CAMDEN CROSSING

PRELIMINARY SITE PLAN

City of Rochester Hills
Planning & Economic Development

Conditions and mark-ups noted throughout the plan set must be addressed prior to final approval.

M2J1, LLC
CAMDEN CROSSING
PRELIMINARY SITE PLAN
COVER SHEET

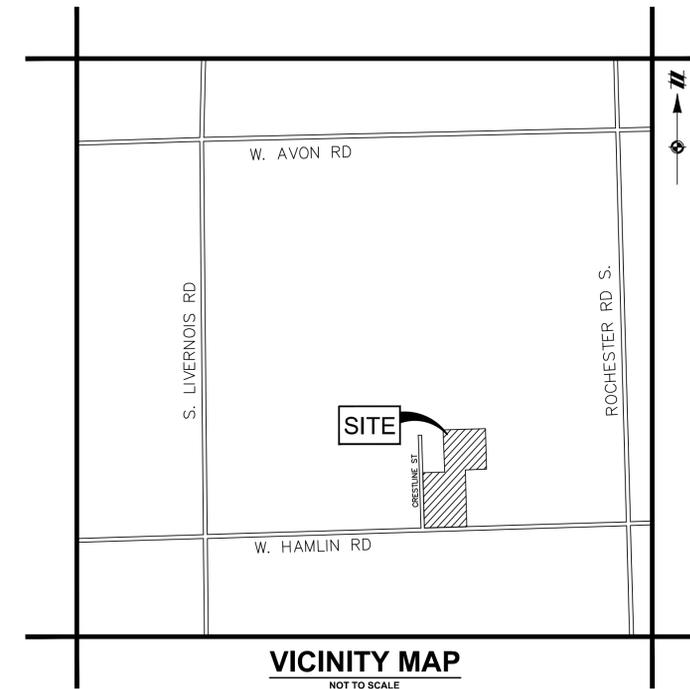
Minimum site area using the MR Overlay is 10 acres. The Planning Commission may modify this requirement if another standard is more reasonable due to existing site or neighborhood conditions or because the site cannot physically comply with one or more of the requirements. In determining whether the modification is warranted, the Planning Commission shall consider the findings for approving a conditional use listed in Section 138-2.302 of the Zoning Ordinance.

Per a phone conversation with John Ackerman of Atwell, LLC on 6/29/2020, the Design Professional intends to use the 2015 Michigan Residential Code for all new structures.

Colored renderings must be provided prior to the Planning Commission meeting.

M2JI, LLC
CAMDEN CROSSING
PRELIMINARY SITE PLAN
SITE LAYOUT PLAN

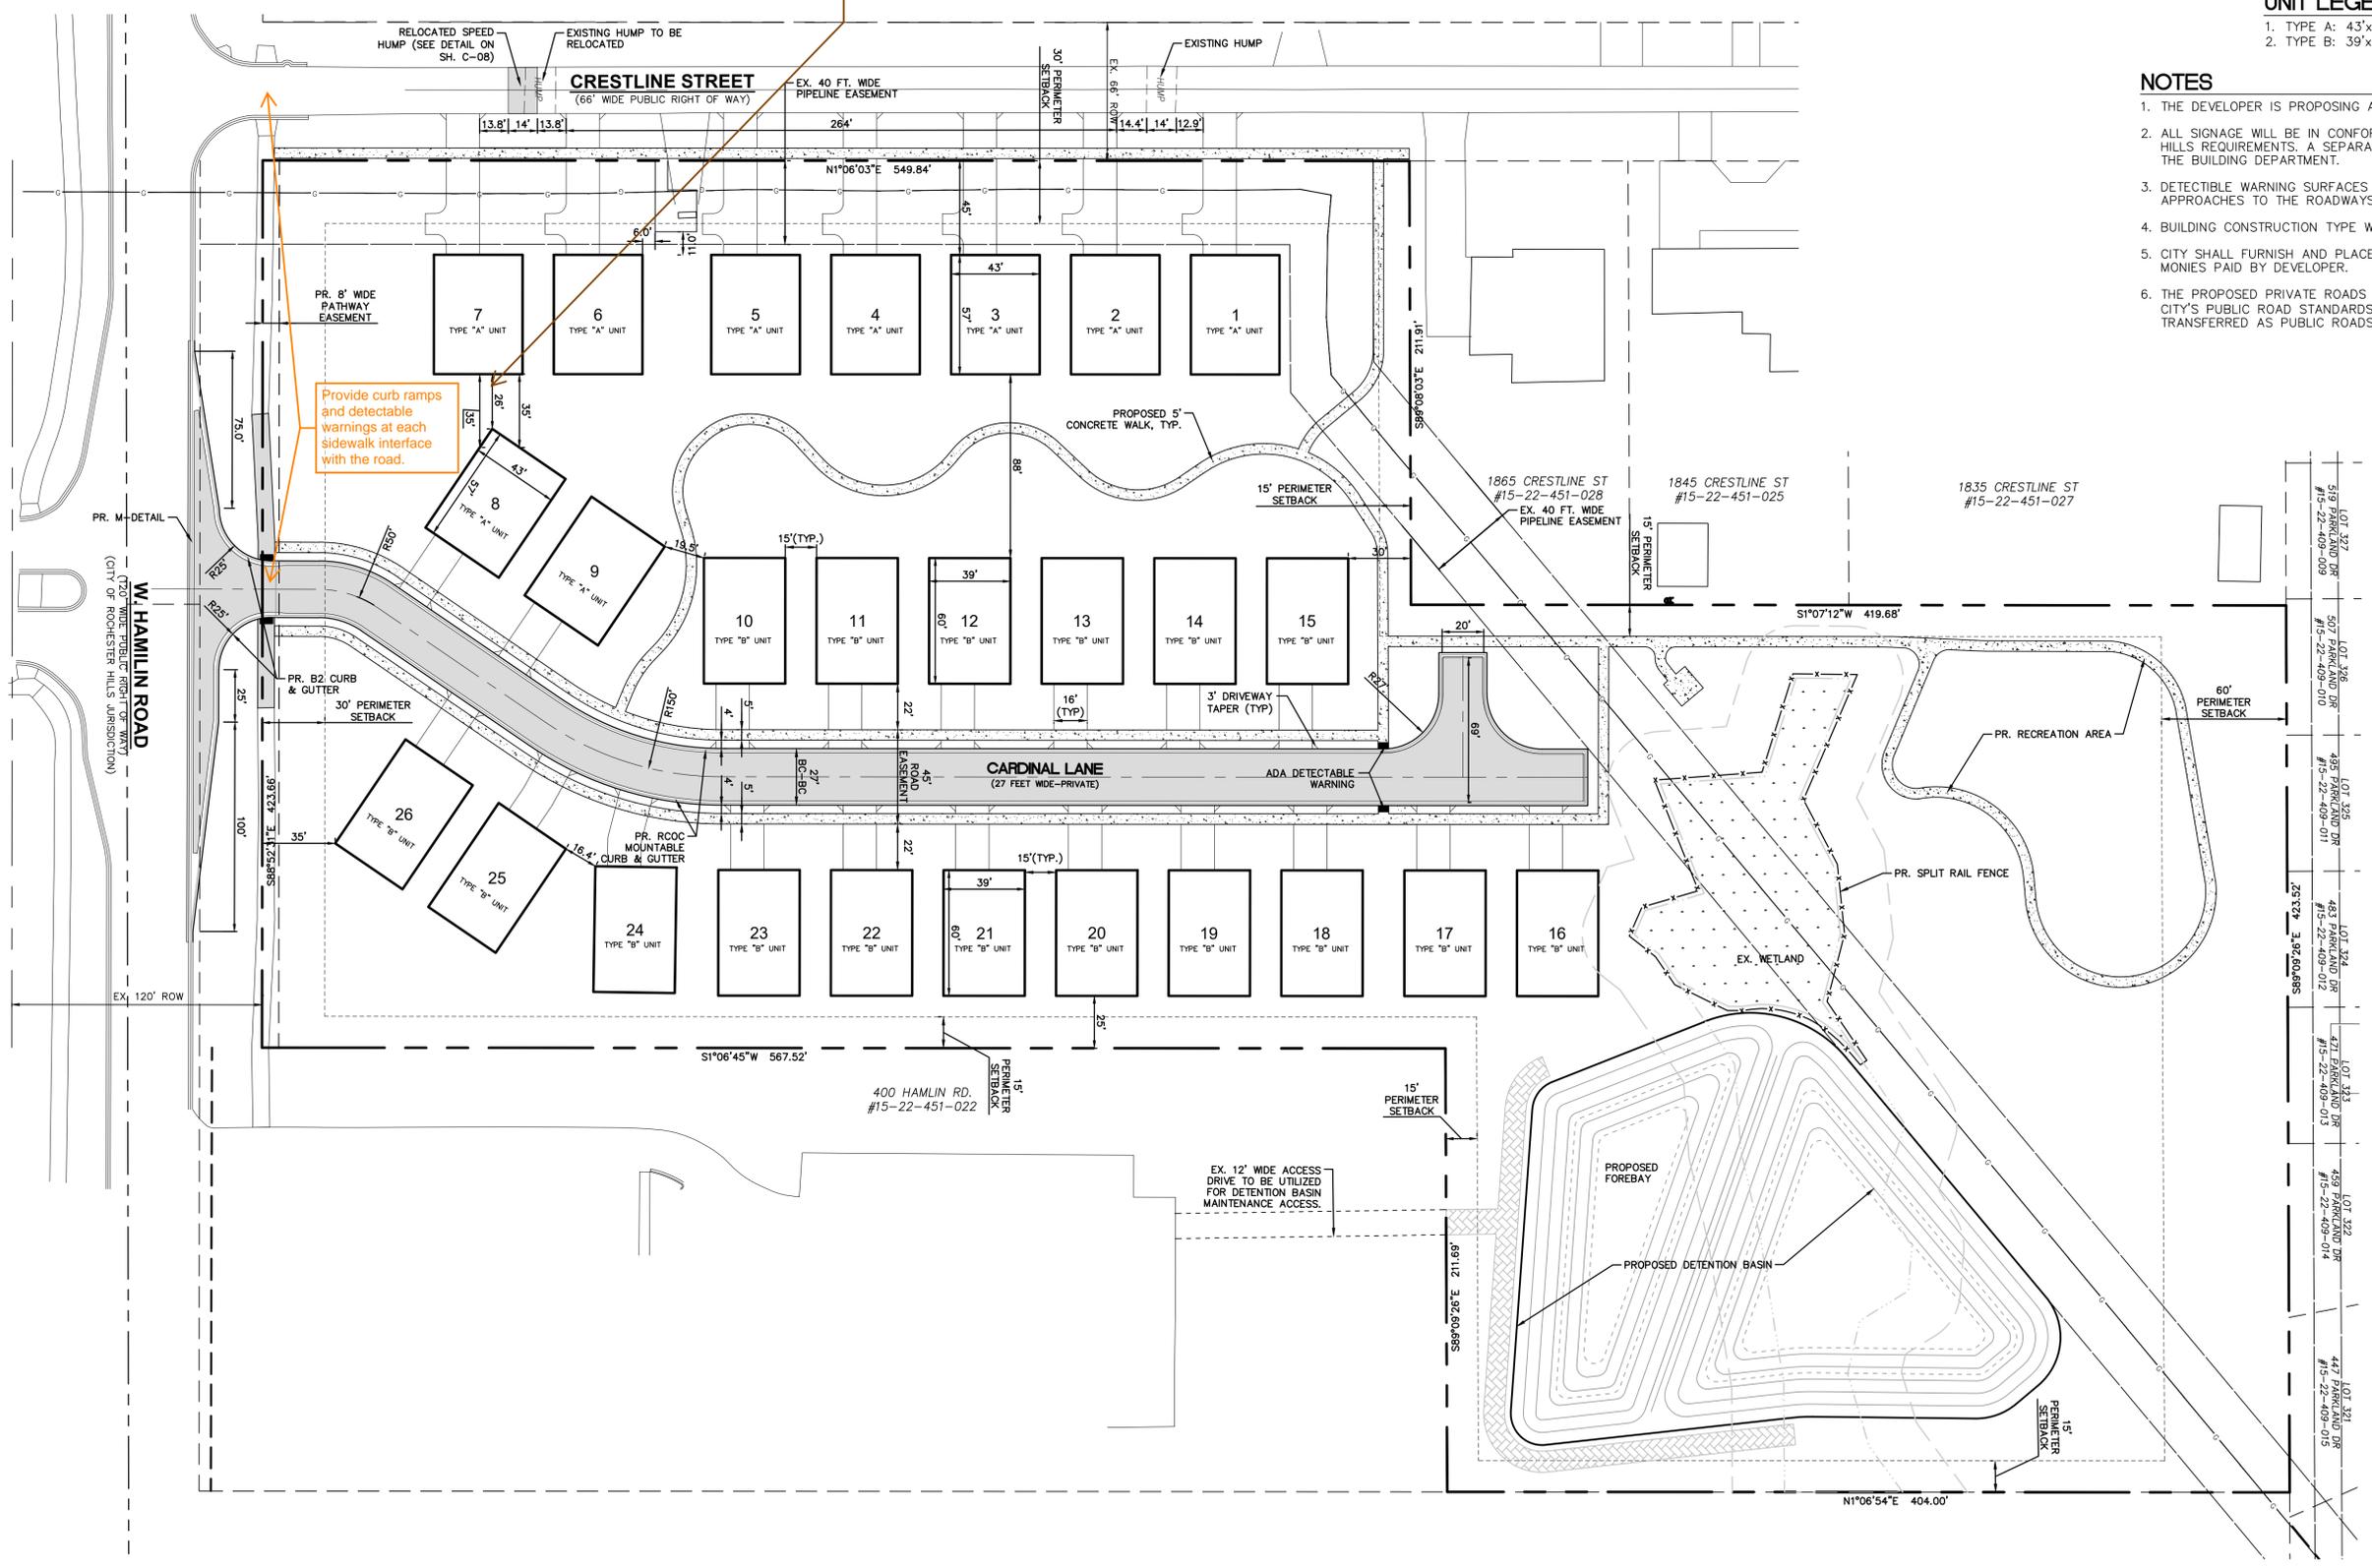
The applicant should not remove any trees until the Land Improvement Permit process has been initiated

The applicant needs to submit a Land Improvement Permit (LIP) application with engineer's estimate, fee and construction plans to proceed with the construction plan review process.

35 ft. interior rear setback required. The Planning Commission may modify this requirement if another standard is more reasonable due to existing site or neighborhood conditions or because the site cannot physically comply with one or more of the requirements. In determining whether a modification is warranted, the Planning Commission shall consider the findings for approving a conditional use listed in Section 138-2.302 of the Zoning Ordinance.

Provide curb ramps and detectable warnings at each sidewalk interface with the road.

M2JI, LLC
CAMDEN CROSSING
PRELIMINARY SITE PLAN
OVERALL DRAINAGE AREA PLAN

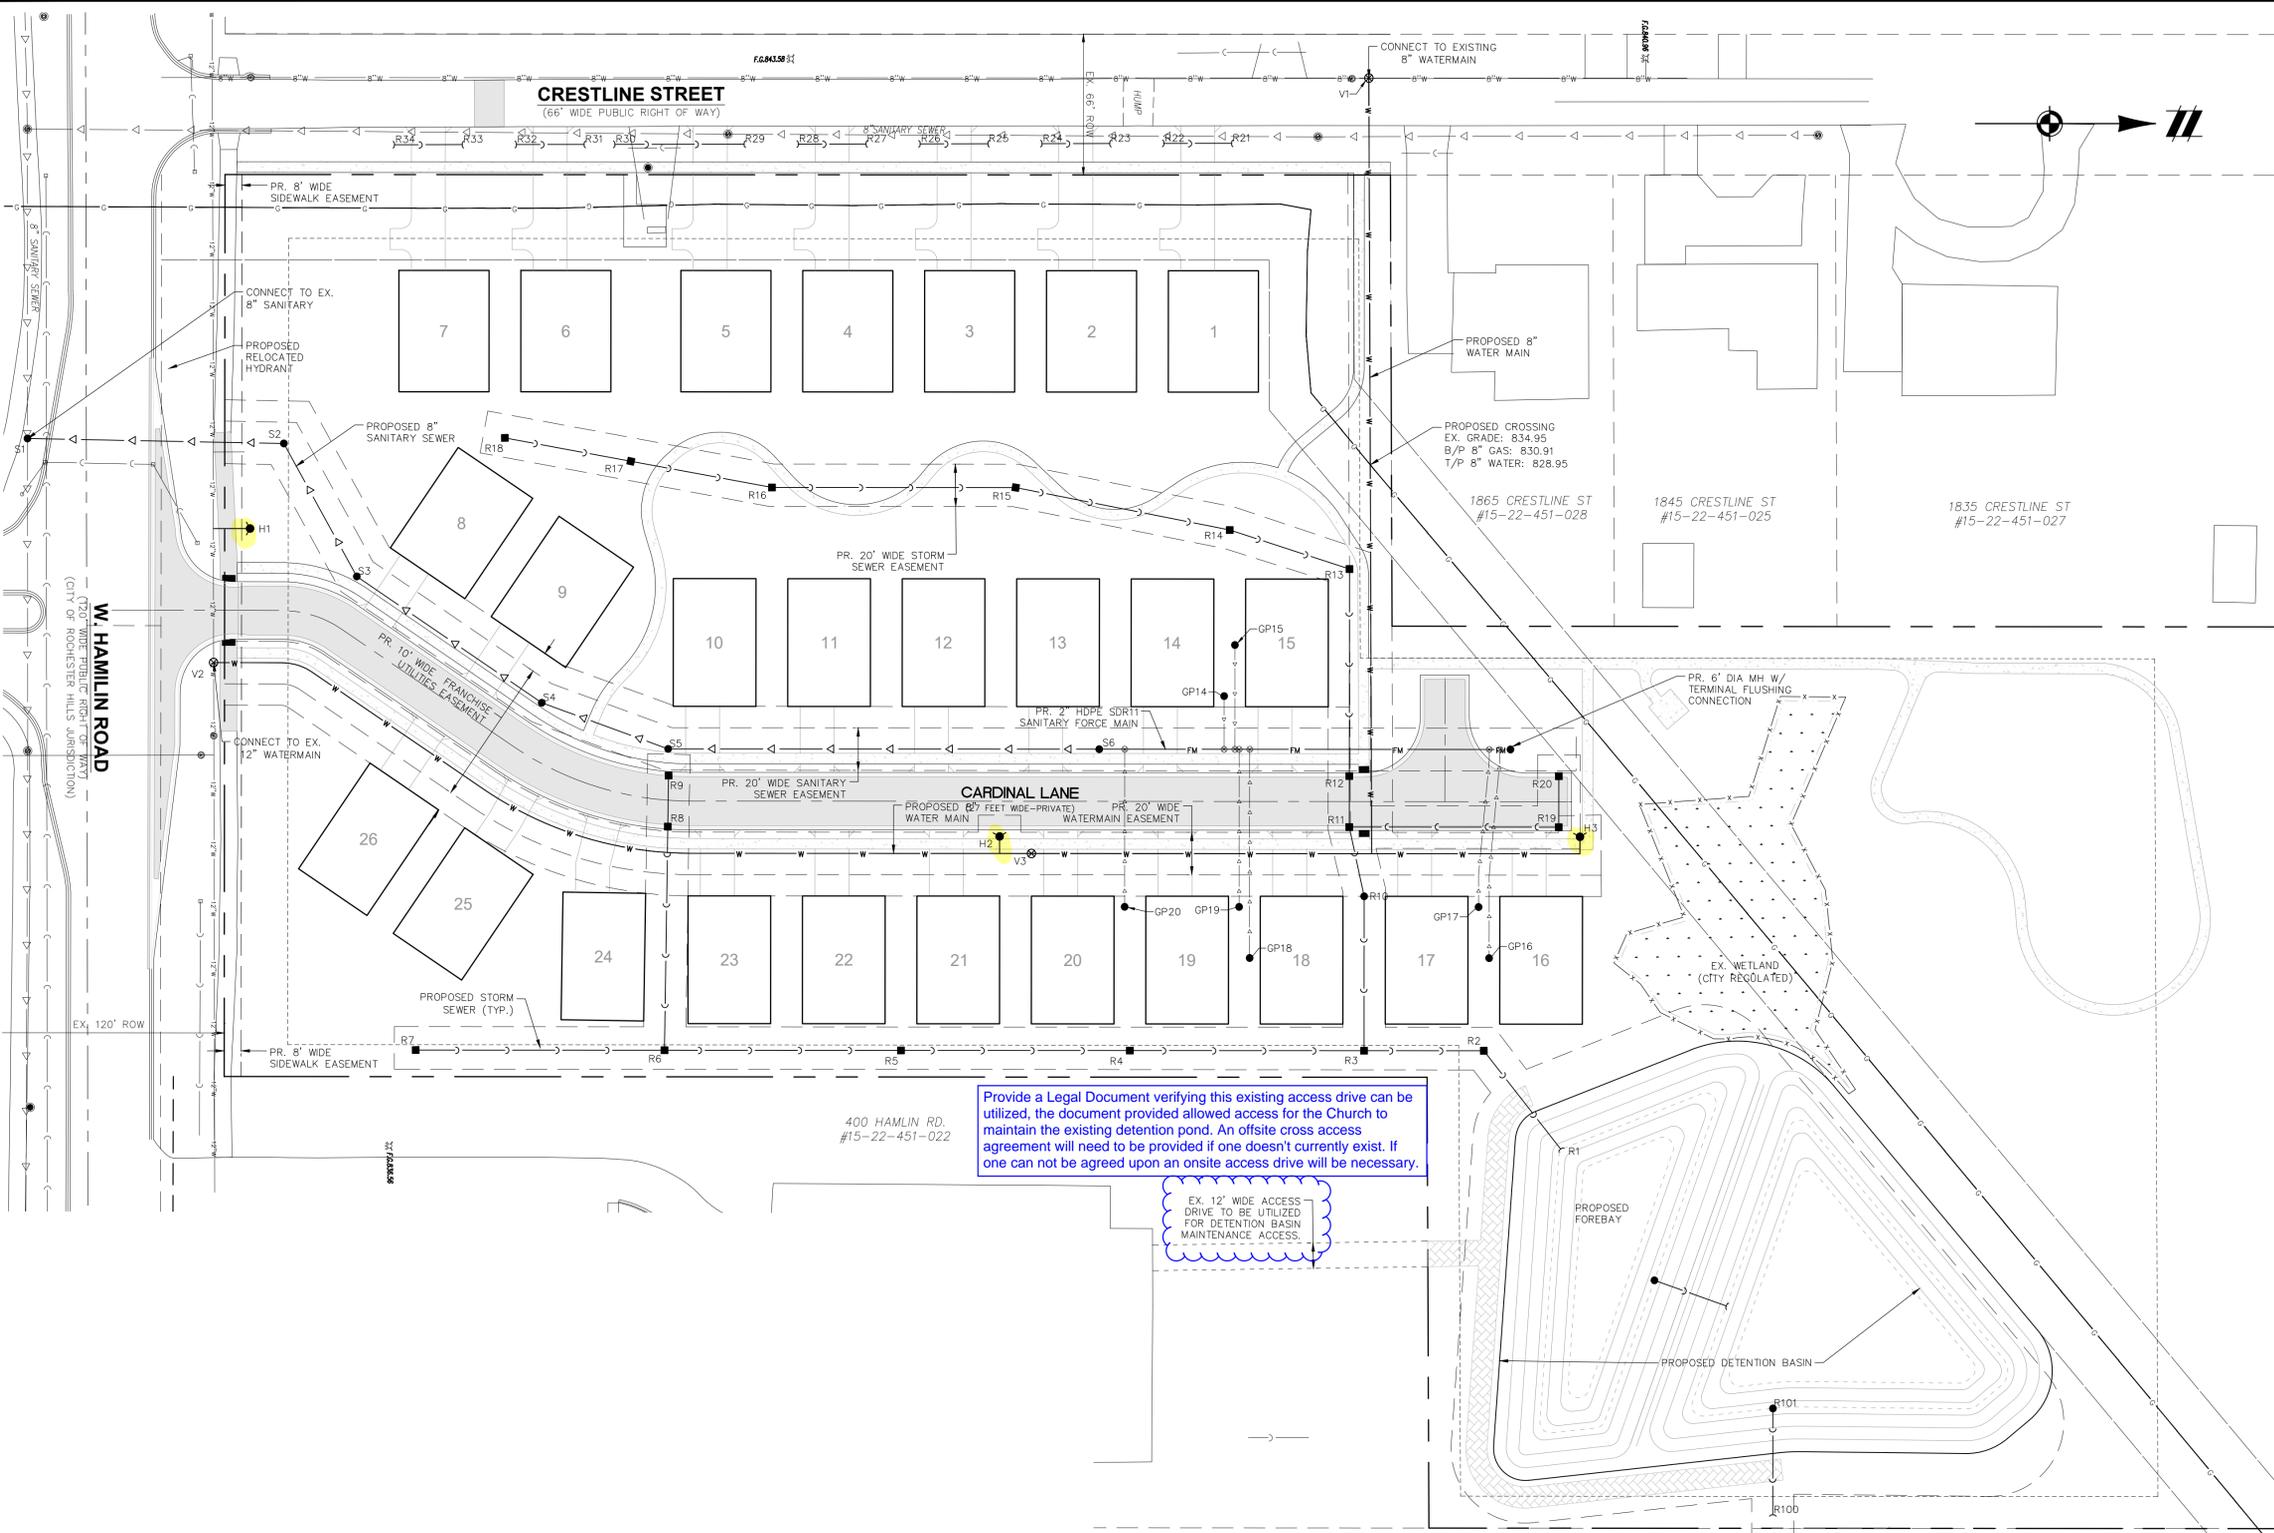
Provide a Legal Document verifying this existing access drive can be utilized, the document provided allowed access for the Church to maintain the existing detention pond. An offsite cross access agreement will need to be provided if one doesn't currently exist. If one can not be agreed upon an onsite access drive will be necessary.
